Proposal for Supplement 2 to the 01 series of amendments to Regulation No. 129

Submitted by the expert from France

The text reproduced below has been prepared by the expert from France, on behalf of the informal group on Child Restraints Systems and supersedes document ECE/TRANS/WP.29/GRSP/2016/22. The modifications to the current text of the UN Regulation and ECE/TRANS/WP29/2016/106 (proposal for Supplement 1 to the 01 series of amendments to Regulation No. 129) are marked in bold for new or strikethrough for deleted characters.

Load application device II

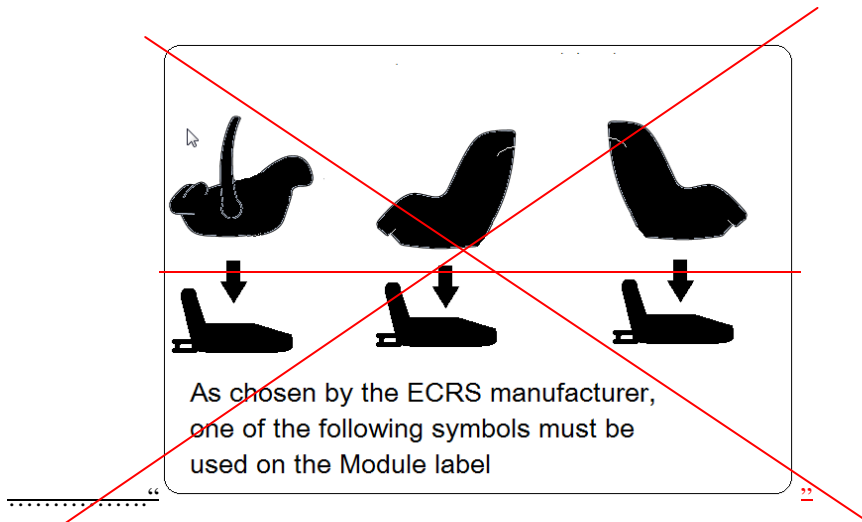
Annex 21. amend to read:

Stretch length	(+/- 5 mm)					
	Q 0	Q 1	Q 1,5	Q 3	Q 6	Q 10
Main belt (A)	1,740 mm	1,850 mm	1,900 mm	2,000 mm	2,000 mm	2,100 mm
Hip belt (B)	530 mm	560 mm	600 mm	630 mm	660 mm	700 800 mm
Lower dimension (C)	125 mm	150 mm	150 mm	170 mm	200 mm	200 mm
Mid dimension (D)	270 mm	300 mm	350 mm	380 mm	380 mm	400 mm

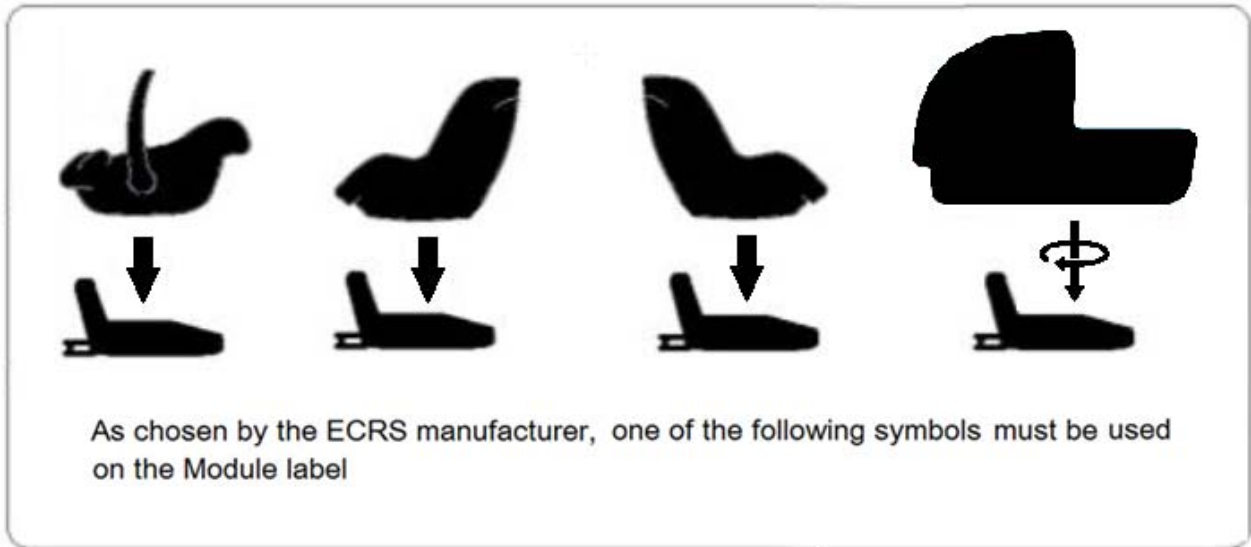
Annex 2 figure, replace module pictures in the last figure in Annex 2 as follows::

In addition, Module label was agreed in the 62nd IG meeting but the image was missed in the informal document GRSP-60-09rev1.
